MEMORANDUM

Re: 1540/1560 Star Top Road Warehousing Development – Road Safety Review

Re: Redevelopment of 1540 & 1560 Star Top Road, Boone Plumbing & Heating Supply Inc.

Preconsultation Feedback Response Submission No. 1

Figure 3 Collisions Within 500 m of Proposed Site

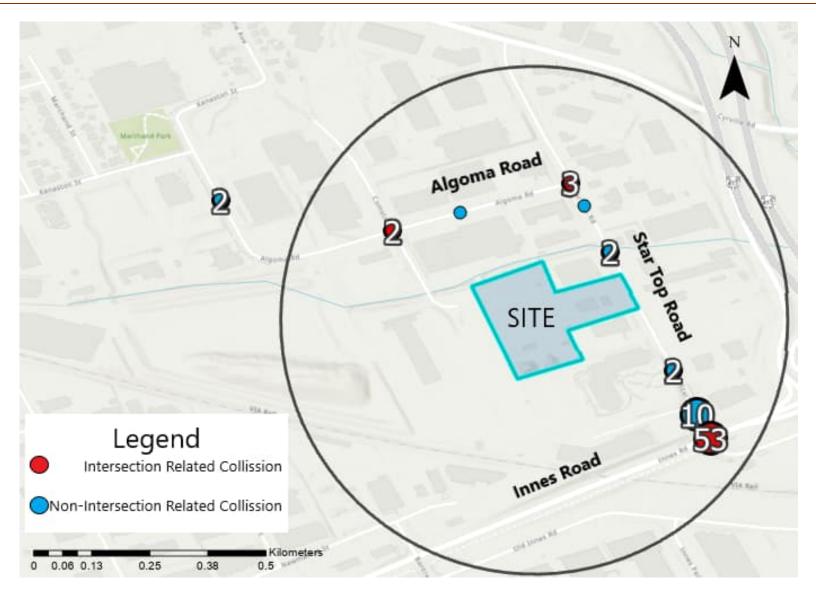
1. Please provide a breakdown of collisions/ identify patterns and identify measures that could be taken to reduce collisions for the Star Top segment between Algoma and Innes. Only Innes and Star Top was provided on the safety review. Ensure the latest collision data (last 5 years, if available) is provided. Contact Nancy.blair@ottawa.ca for collision data request.

REPLY: A request for additional collision data was submitted on October 23, 2023. A response to this comment will be provided upon receipt of the most recent collision data.

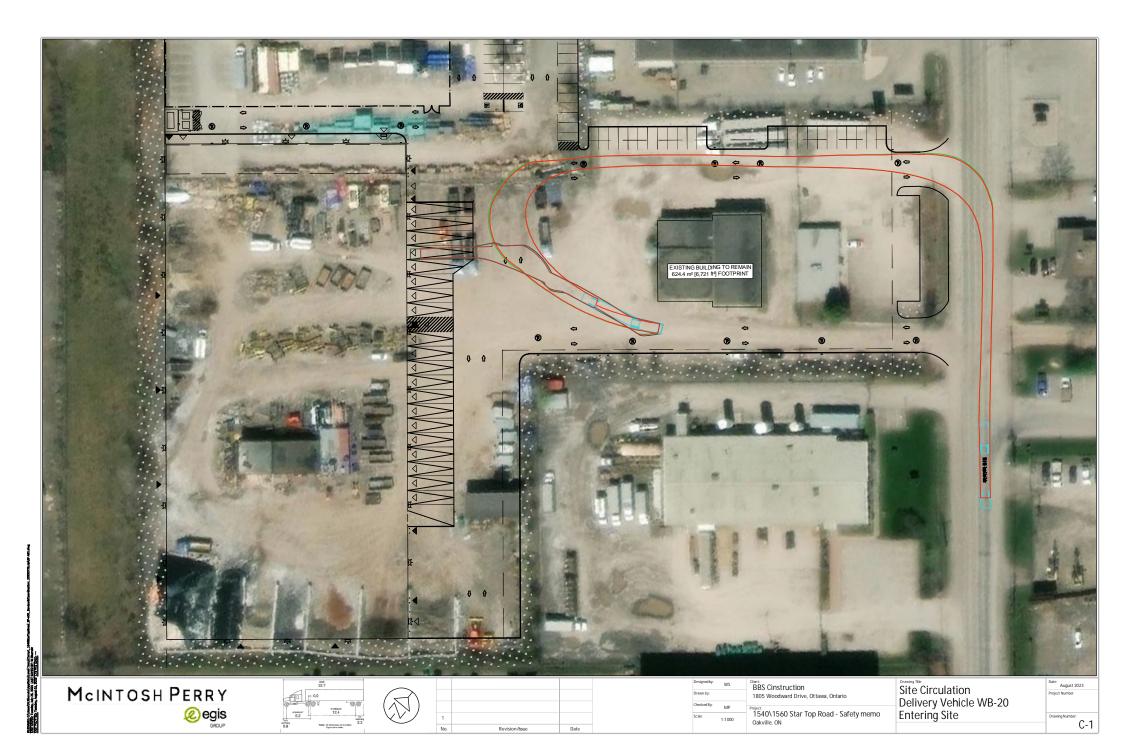
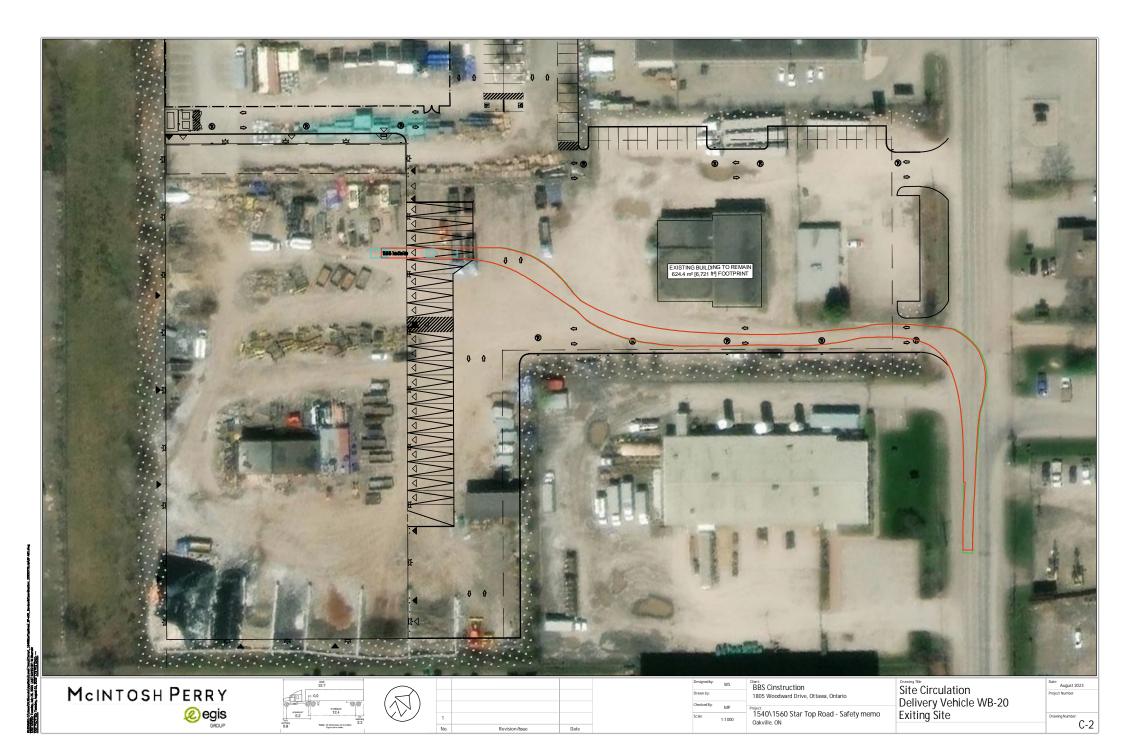
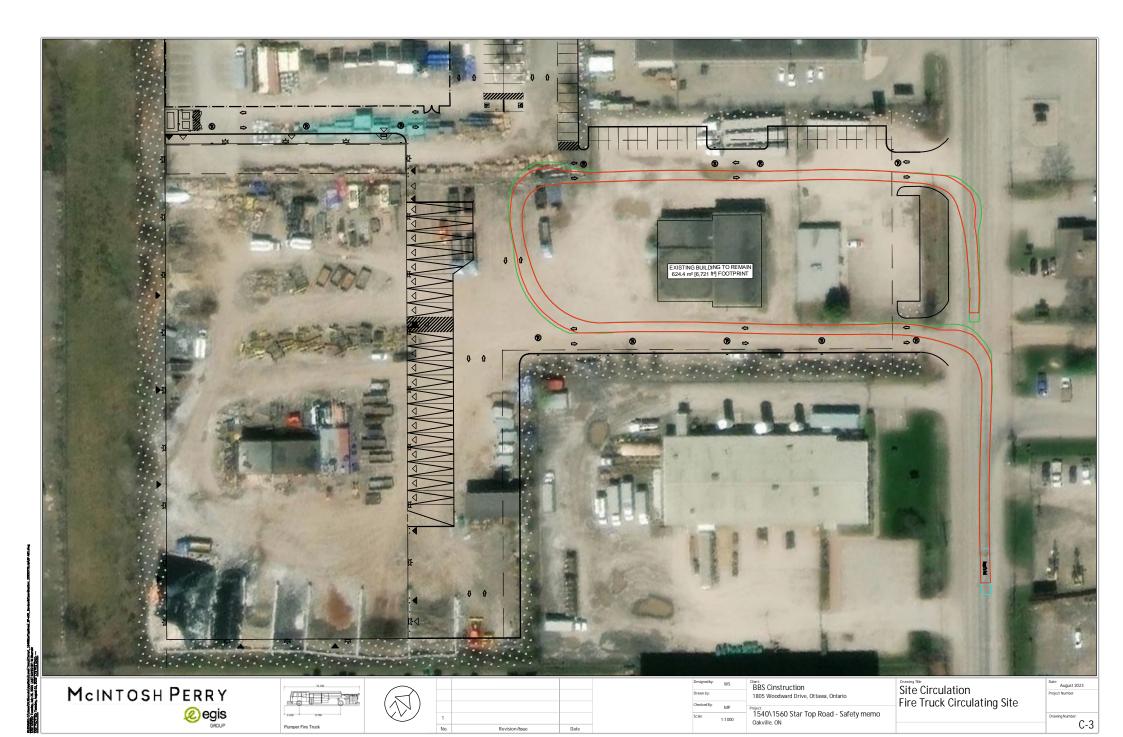
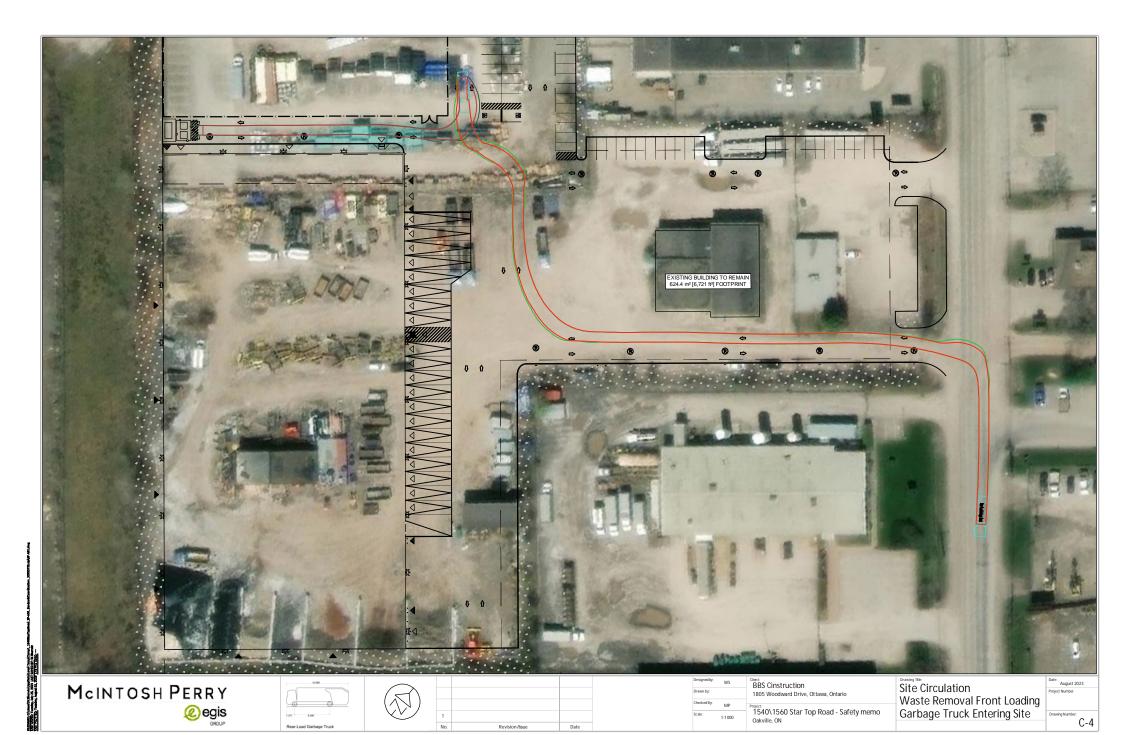
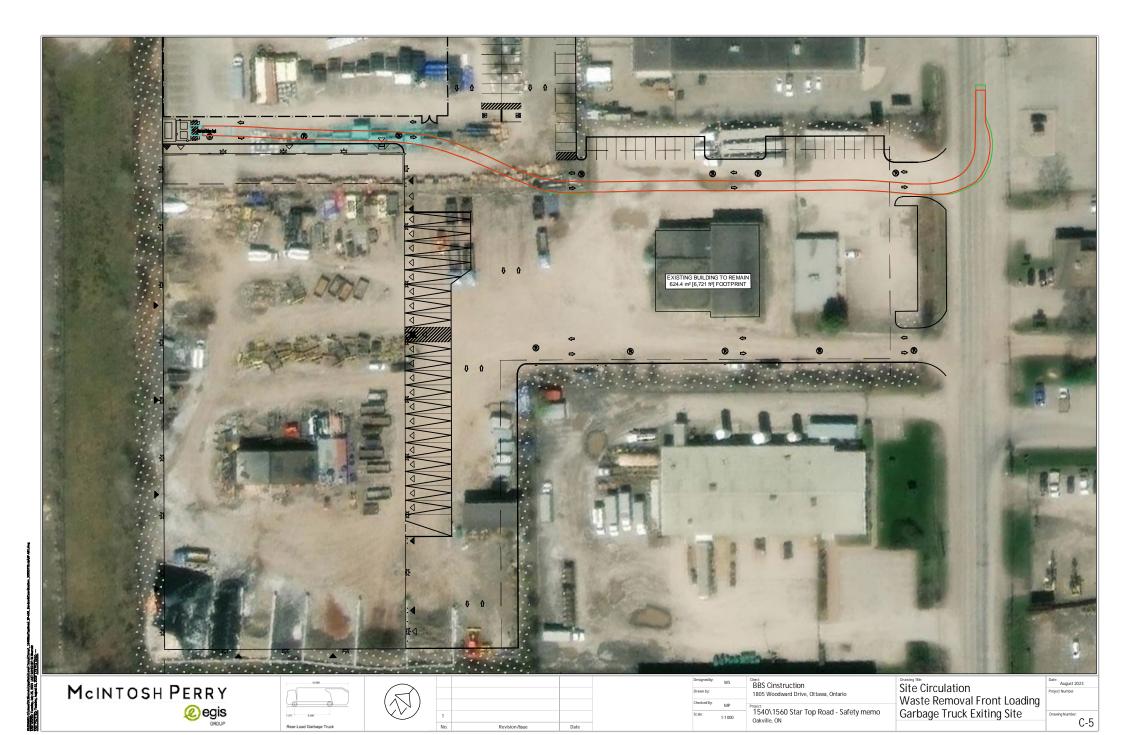
4. Confirm that the fire truck turning movement does not conflict with the existing curb close to the southerly access (Drawing C-3).

REPLY: The existing curb close to the southerly access is proposed to be removed.
